MEMORANDUM

Agenda Planning Commission

City of Decatur, AL

April 22, 2014

CERTIFICATE TO SUBDIVIDE AND CONSOLIDATE 3238-14

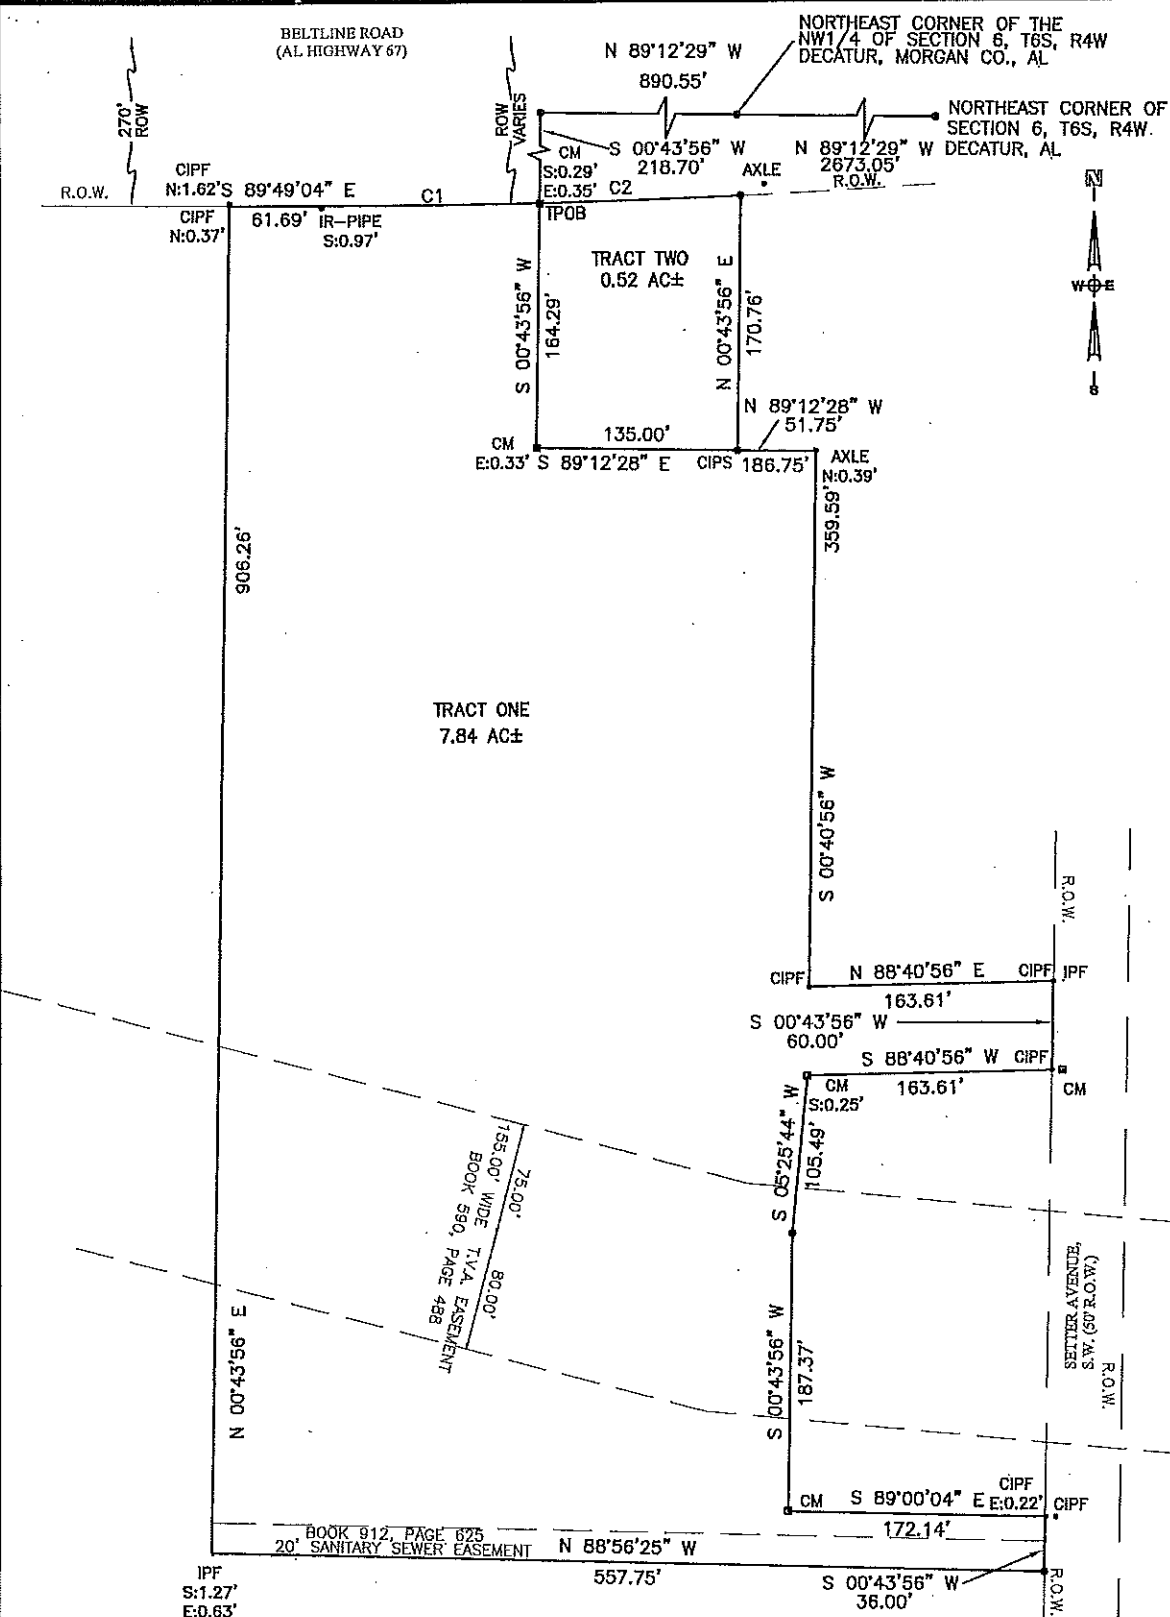
1. Payment of recording fees
2. Provide copy of deed showing ownership of property
3. Show correct ownership in body of certificate
4. Verify/obtain septic tank approval for Unit 2 or extend sewer
5. Provide copy of letter from owner requesting subdivision

Pt. of Info: Any relocation of utilities will be at the owner's expense.

Recomm: Approval with stated conditions

THE FARM SIDEWALK CONSTRUCTION PLAN
APPROVED BY PLANNING COMMISSION MAY 09

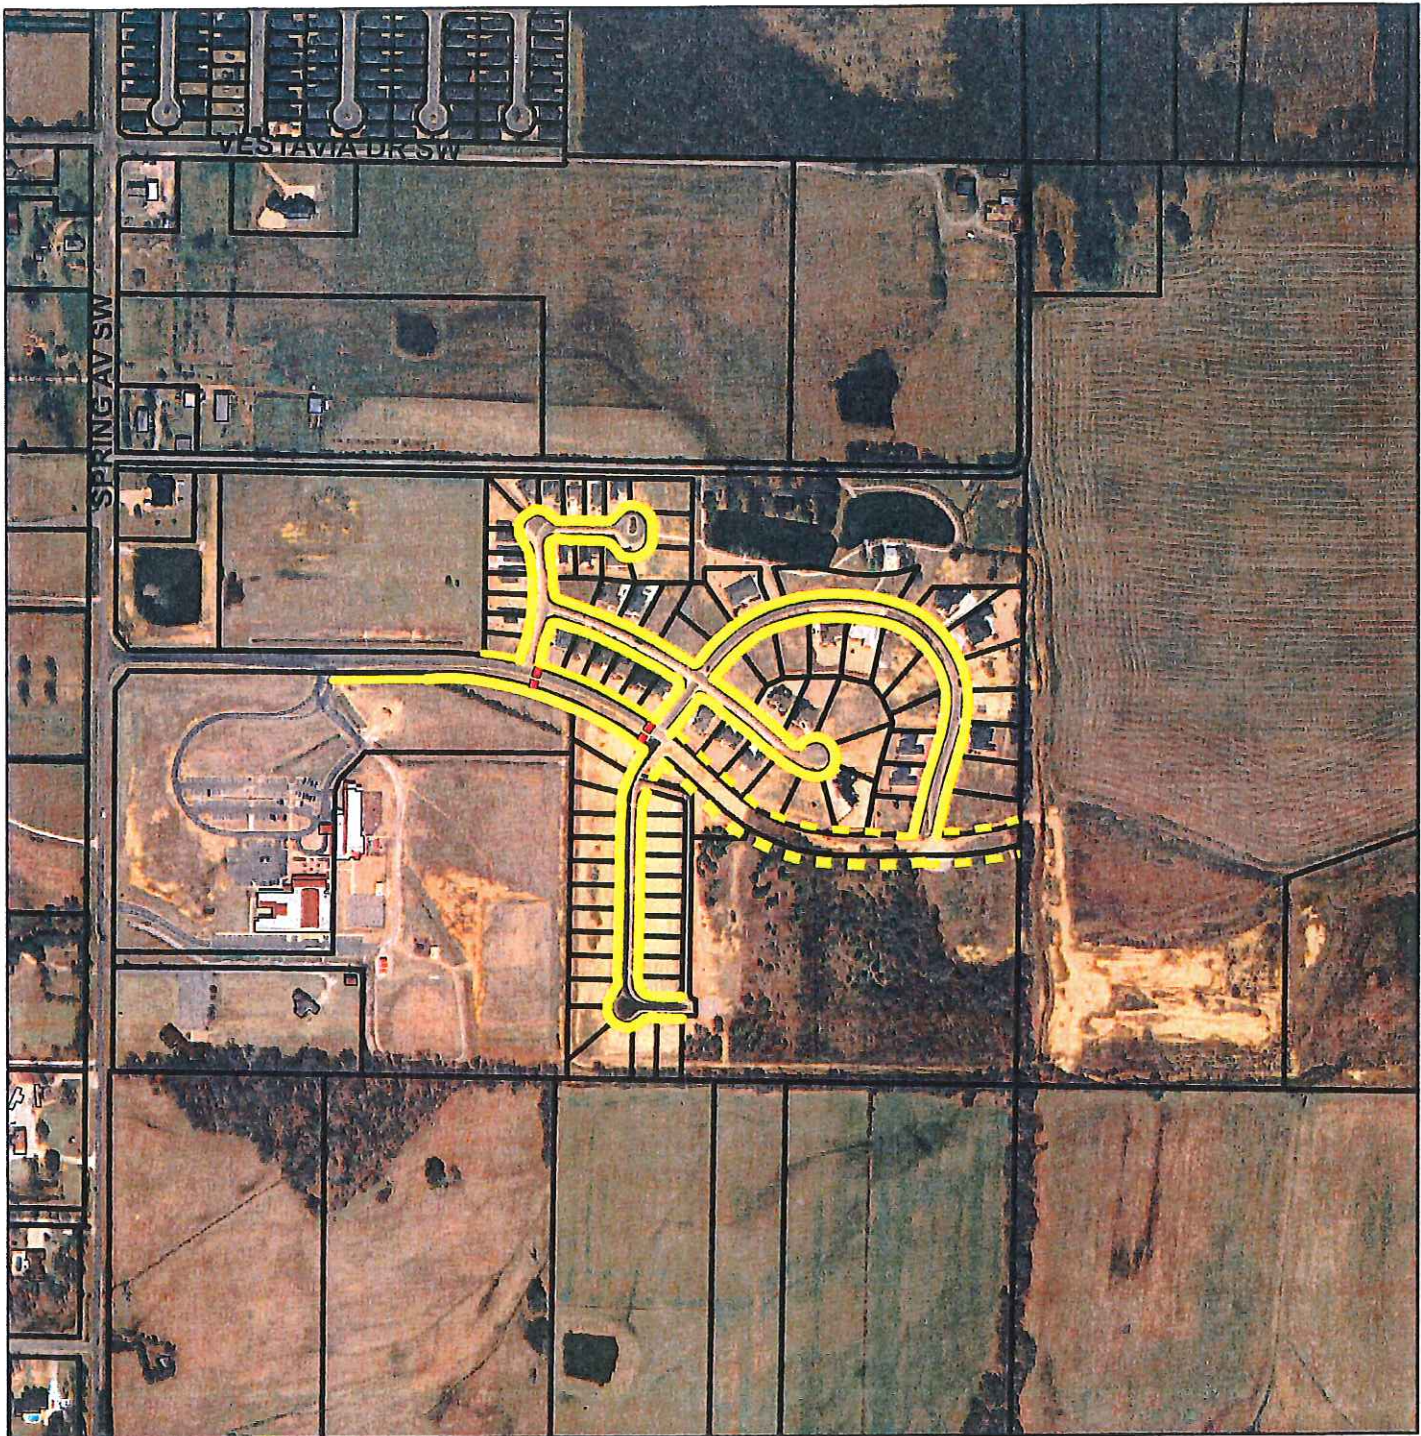
Request: Bond review for the completion of public improvements – (sidewalks and the extension of Bridle Path). LOC's expire June 19, 2014. Sidewalk Amount - \$25,000. Extension of Bridle Path Amount - \$80,000.

Recomm: The Subdivision Committee recommends that the sidewalk on Bridle Path be constructed and The LOC released upon completion of the work. The LOC for the extension of Bridle Path would need to be continued until such time as future development requires the extension of the collector.
